Philips Domestic Appliances and Personal Care

Service Manual

FC9012

To recognize the switches:

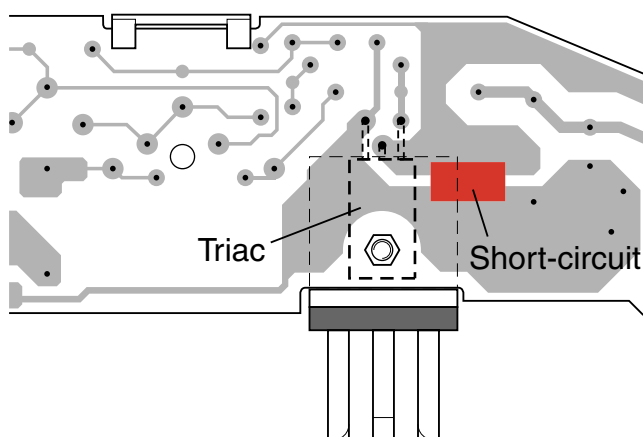
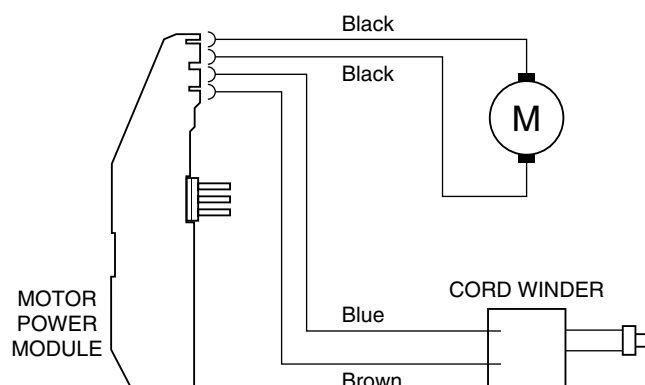
- Due to introduction of a **new switch** (item 11) 0320 onwards, which is not interchangeable with the old switch soldered on the PCB (item 12).
- The switch lever assy (item 11a) is also modified.

New spares are:

| Switch soldered version | - 4322 006 50600 |
| Switch lever assy | - 4322 009 08980 |
